{In Archive} 980 Hurricane Road, Franklin, IN - Two Critical Questions

Please find enclosed TechLaw's review comments on the above-referenced document and additional work as outlined in the Technical Direction Memorandum (TDM) dated June 8, 2001 (received on June 25, 2001) for Franklin Power Products Inc. and Amphenol Corporation. For your convenience, the main body (i.e., text) of this deliverable was E-mailed directly to you and Mr. Juan Thomas in WordPerfect for Windows format. In addition, several graphs, tables, and figures were developed and are also provided with this deliverable. While the included figures are hand modified and are not available electronically, electronic copies of the graphs and tables can be provided if requested.

Re: Franklin Power Products, Inc./Amphenol Franklin, Indiana Administrative Order on Consent USEPA I.D.# IND 044 587 848 Response to Comments

Re: Administrative Order on Consent (dated November 27, 1990) Interim Final Decision/Response to Comments Franklin Power Products/Amphenol IND 044 587 848

Figure 1. Soil sampler assembly.

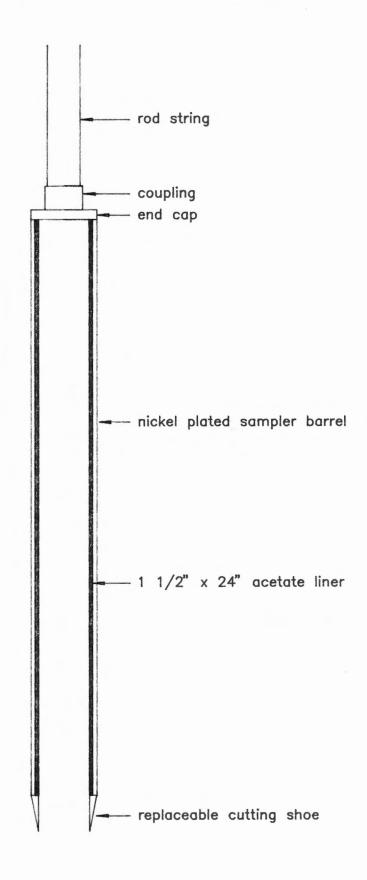
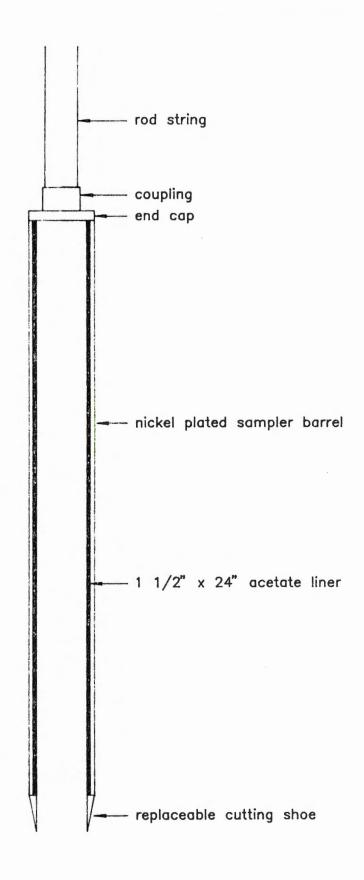
Two special sampling points will be used. The first is a soil sampler with two-foot long acetate inserts (Figure 1). The sampler is capable of recovering a soil core up to 24 inches long and 1.5 inches in diameter. The sampler is installed at the bottom of the sampling string and is advanced with the air hammer. After being advanced for two feet, the sampler is withdrawn and the soil sample removed for description. Continuous soil samples can be collected in this manner.

Figure 2. Screened ground water sampler.

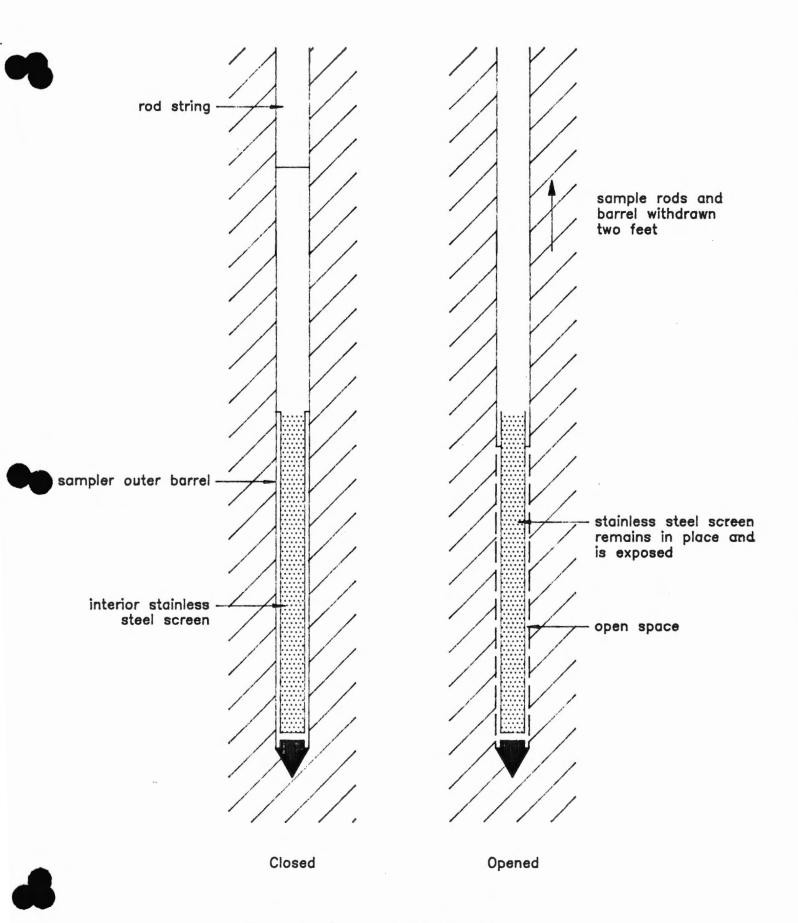
The second point is a screen point ground water sampler (Figure 2). This sampler is installed at the bottom of the sampling string and is advanced hydraulically or by air hammer to the desired sampling depth with decontaminated stainless steel rods. While driving, the point is sealed from outside contamination. At sampling depth, the sampling string is withdrawn two feet, the 0.0057" screen is exposed, and water enters the sampler. The water can then be retrieved to the surface by a Teflon or stainless steel mini-bailer, or pump. The bailers are 7/16" OD and 20 inches long with a ball and seat.

Figure 4. Locations of proposed Geoprobe sampling points.

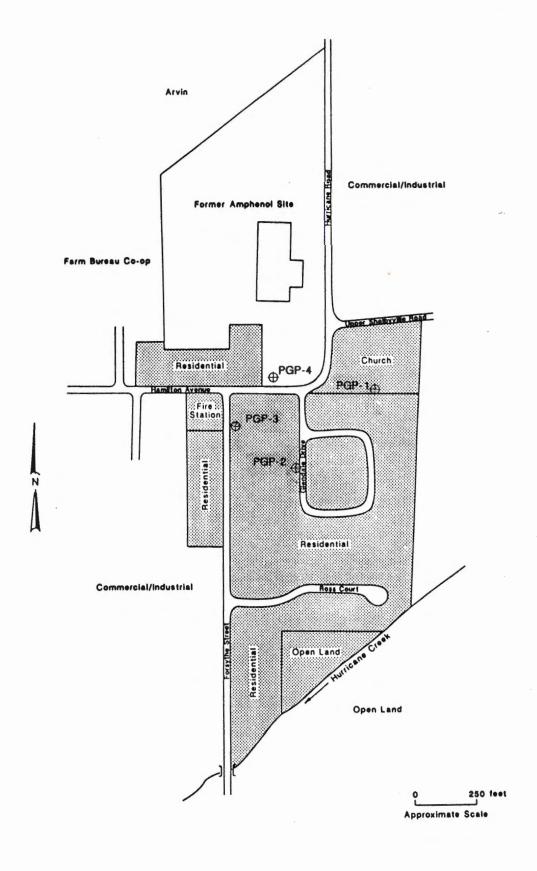
See Figure 4. Ground water samples are proposed at four locations: between former Geoprobe locations SGP-6 and SGP-7 (PGP-1), south of GNS-4 (PGP-2), along Forsythe Street south of its intersection with Hamilton Avenue (PGP-3), and adjacent to MW-12 (PGP-4). The latter sample will be used as a check against standard screened well and bailer sampling that will also be conducted at MW-12. To assure that the edge of the plume is being monitored at PGP-3, water samples will be collected at several locations in the vicinity and analyzed using the on-board purge-and-trap GC before selecting the sampling point for the CLP samples.
